# Base Function FPGA Heatsink

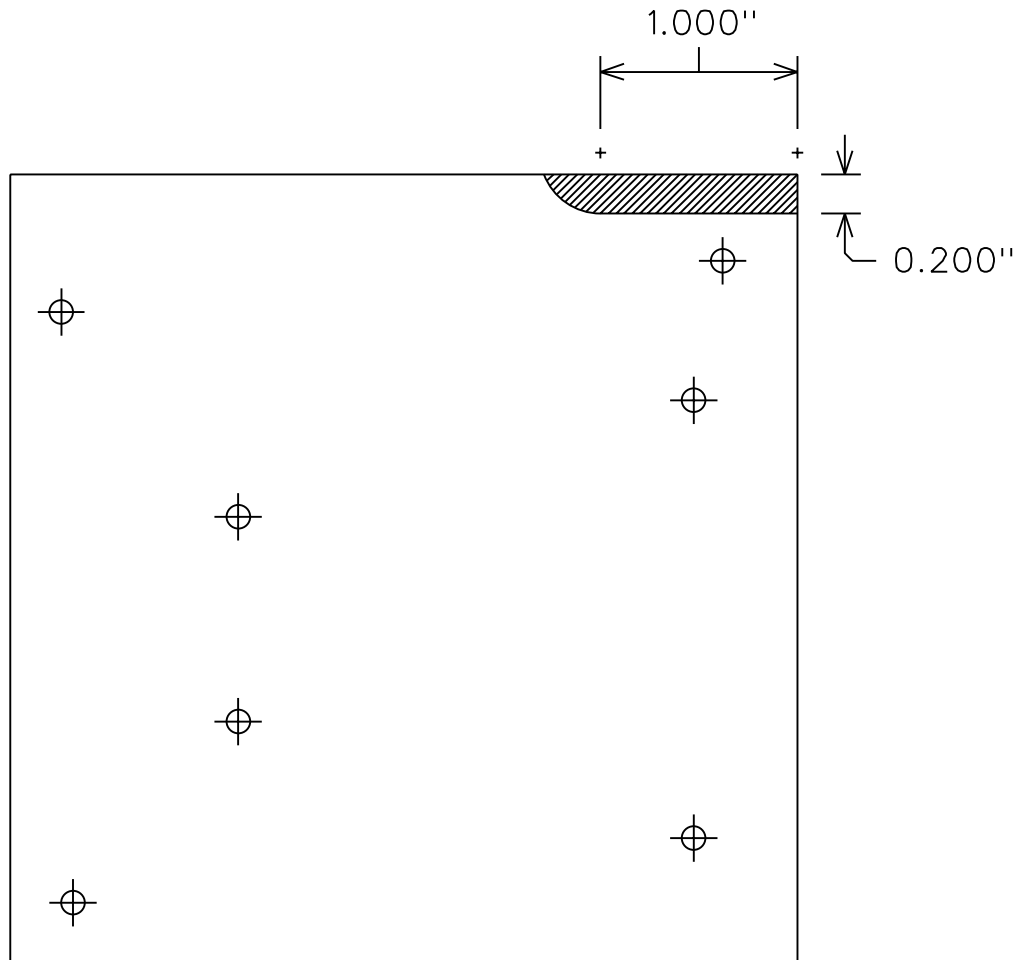
This drawing shows the area from which
30 mills should be removed from this
flat side of the heat sink.

The tick marks show the motion of the
center of a $\frac{1}{2}$" end-mill that could be
used to remove this material.
